The District of Columbia
Office of Planning
Anita Cozart, Interim Director

# **Commemorative Works Committee Meeting**

January 21, 2022

**Second and Final Review**

**Commemorative Work Proposed Site**

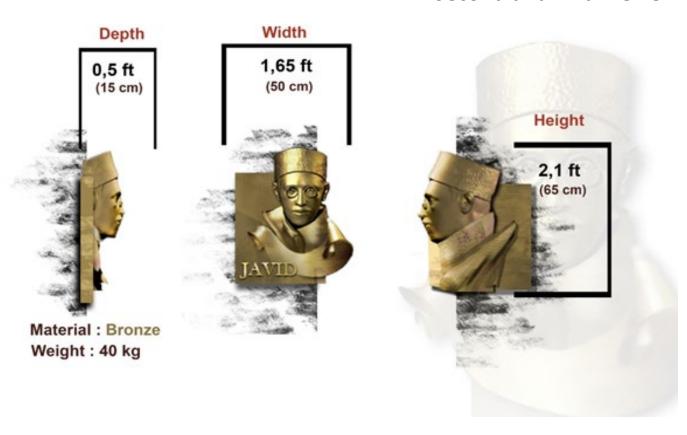
• Commemorative work has been redesigned as a bronze frieze attached to the building and projecting into public space.
